**HISTORIC PRESERVATION REVIEW BOARD
STAFF REPORT AND RECOMMENDATION**

Landmark/District: **Walter Reed Army Medical Center Historic District** (x) Agenda
Address: **6800¹ Georgia Avenue NW**

Meeting Date: **April 27, 2017** (x) New construction
Case Number: **17-304** (x) Alterations

Staff Reviewer: **Tim Dennée** (x) Concept

A detail of the 2015 master plan.

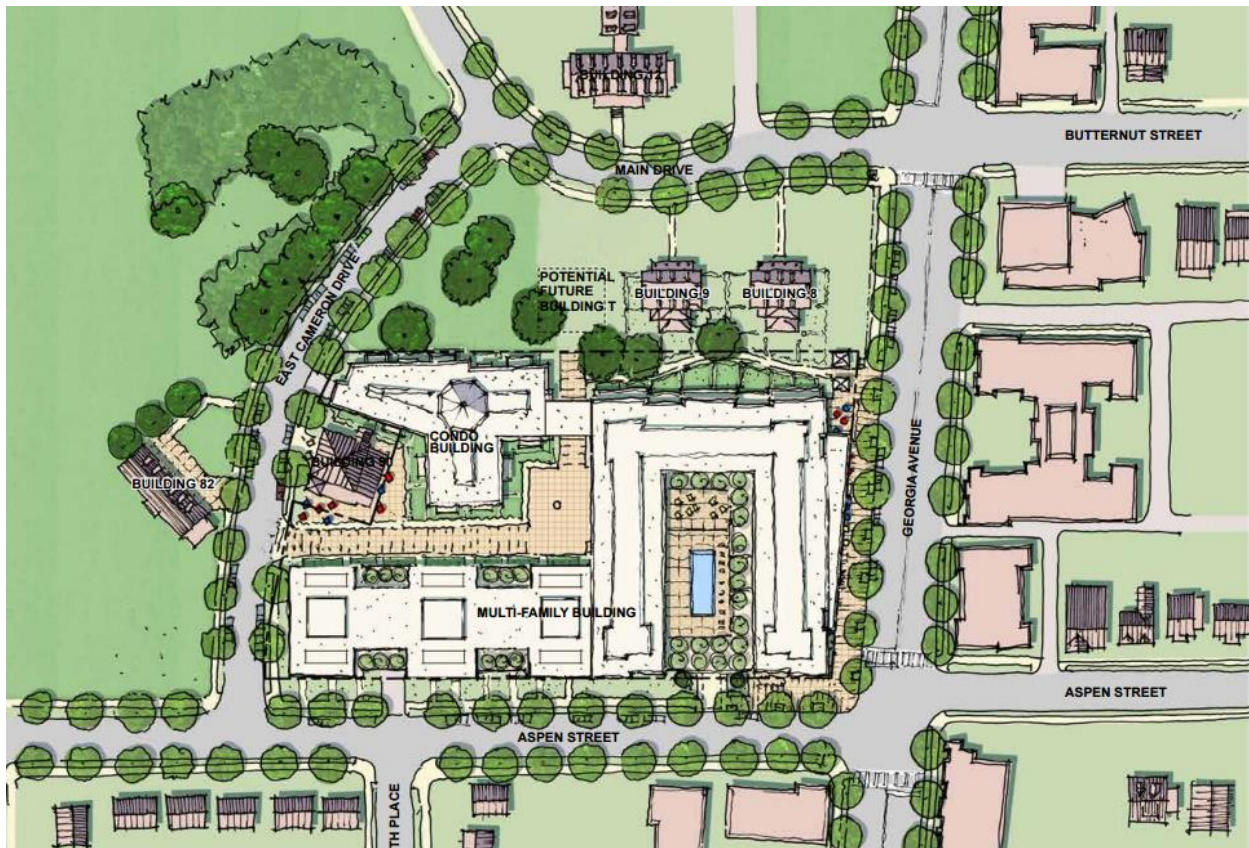
Building U/V, southeast corner of the campus (see pages 46-49): Another five-story building, this site would most benefit from having a specific program attached to it, so that the reality of the project, and especially the building's footprint, could be properly evaluated. It is quite close behind the General Officers' Quarters, Buildings 9 and 10. The simulation makes it appear that there is an attempt to step down toward those buildings (see page 47), but the inset site plan seems to put that mass almost immediately behind Building 8. The good thing about the footprint of the building is that it is broken up into north-south pavilions that would face Buildings 8 and 9 end on. Yet, the whole is sprawling and not only close to those historic buildings, but wraps around the contributing fire station, Building 90. Some credit should be given, however, to forgoing an additional building in the heavily treed area west of Building 9...
